Project	IEEE 802.16 Broadband Wireless Access Working Group < http://ieee802.org/16 >	
Title	In-band Transparent Relay Frame Structure	
Date Submitted	2006-03-13	
Source(s)	<p>Kanchei (Ken) Loa, Yi-Hsueh Tsai, Yung-Ting Lee, Heng-Iang Hsu Shiann-Tsong Sheu, Frank C.D. Tsai, Youn-Tai Lee, Chih-Chiang Hsieh, Hua-Chiang Yin, Institute for Information Industry 8F., No. 218, Sec. 2, Dunhua S. Rd., Taipei City, Taiwan.</p> <p>Gang Shen, Kaibin Zhang Alcatel-Lucent, Research & Innovation 388#, Ningqiao Road, Shanghai, China.</p> <p>[add co-authors here]</p>	<p>Voice: +886-2-2739-9616 loa@iii.org.tw</p> <p>gang.a.shen@alcatel-sbell.com.cn</p>
Re:	IEEE 802.16j-07/007r2: "Call for Technical Comments and Contributions regarding IEEE Project 802.16j"	
Abstract	This contribution proposes in-band transparent relay frame structure	
Purpose	Text proposal for 802.16j Baseline Document	
Notice	This document has been prepared to assist IEEE 802.16. It is offered as a basis for discussion and is not binding on the contributing individual(s) or organization(s). The material in this document is subject to change in form and content after further study. The contributor(s) reserve(s) the right to add, ame

Figure yyy Example of configuration for an in-band transparent relay frame structure

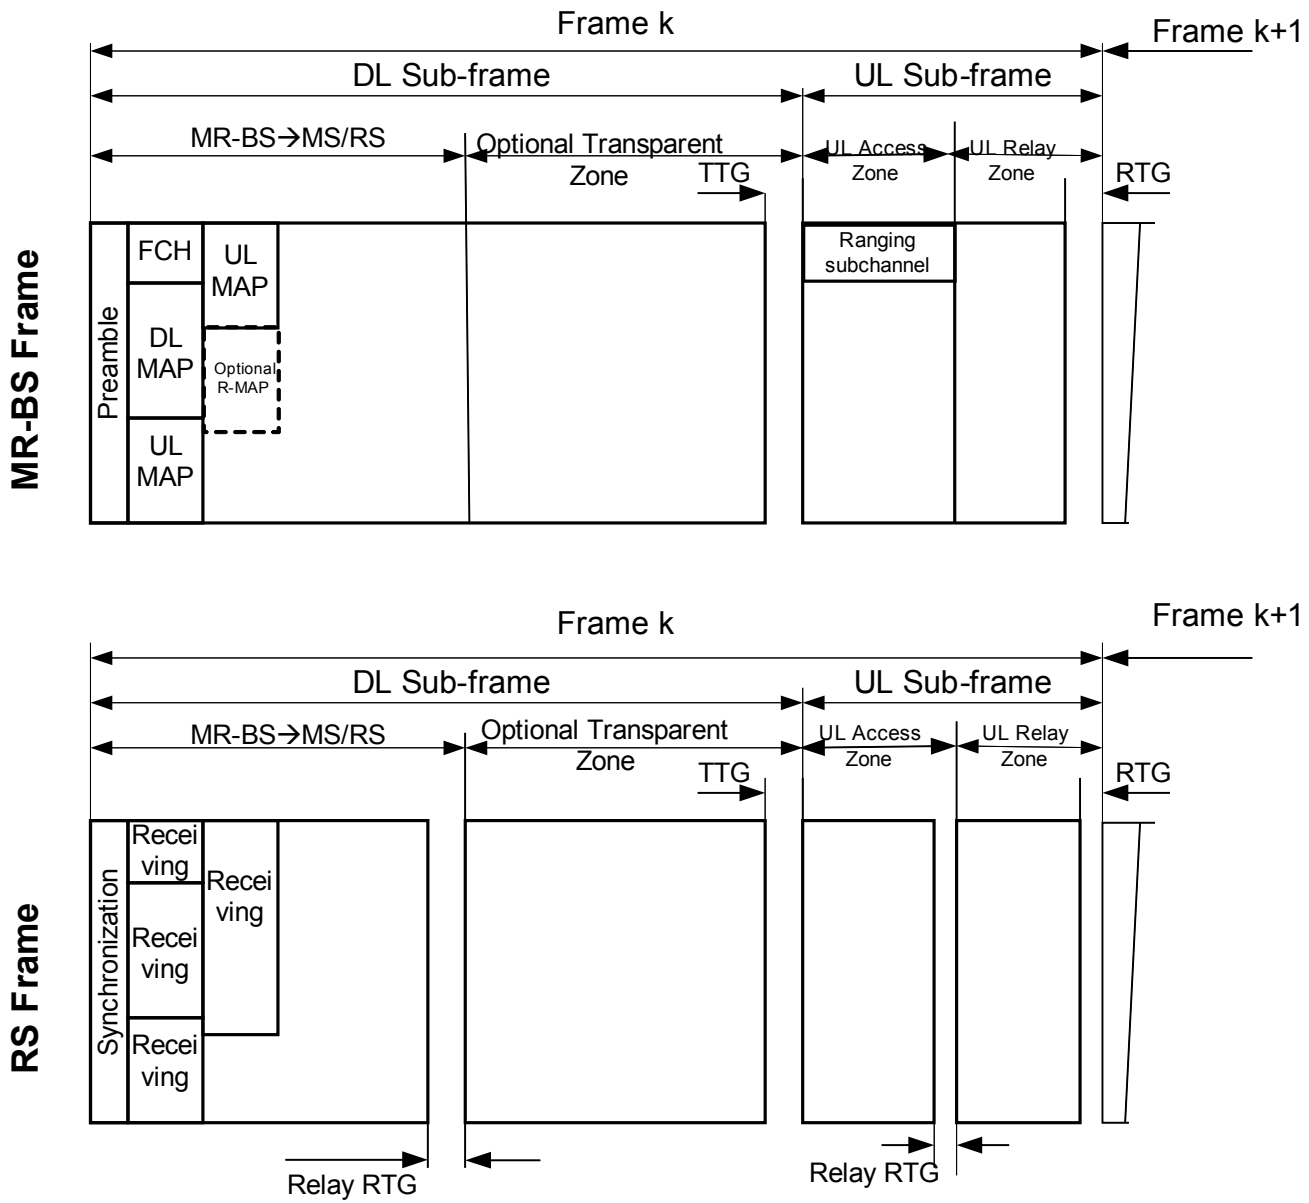
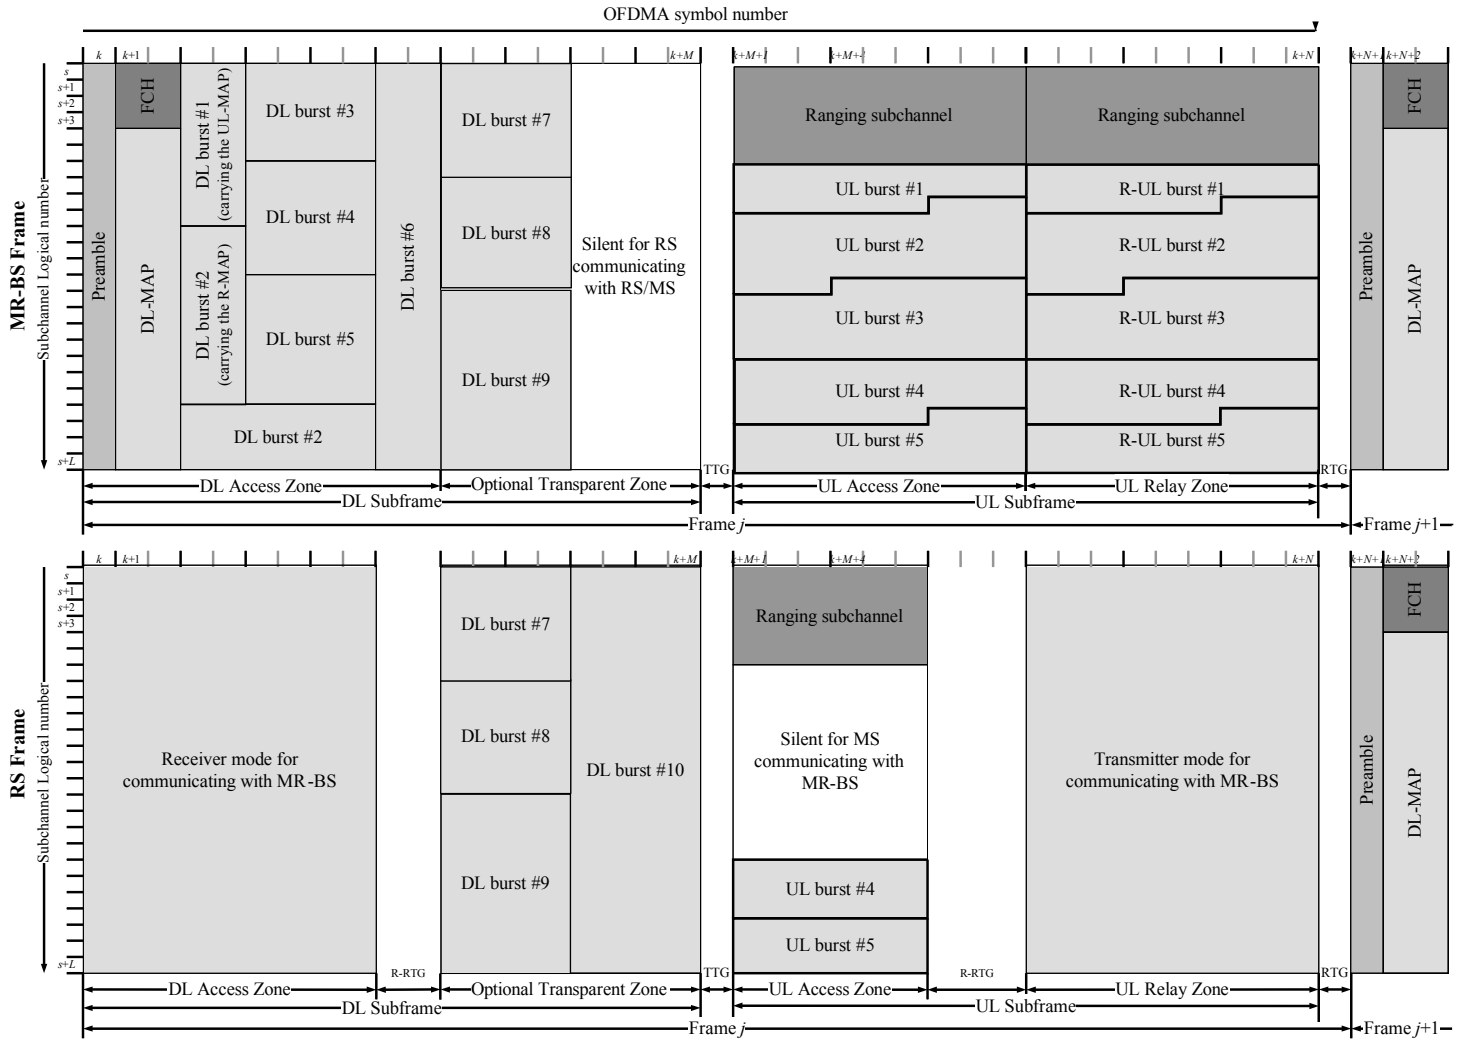
[Change the figure in section 8.4.4.7.1 “Frame structure for transparent mode” as indicated:]

[Replace Figure xxx with Figure yyy as follows:]
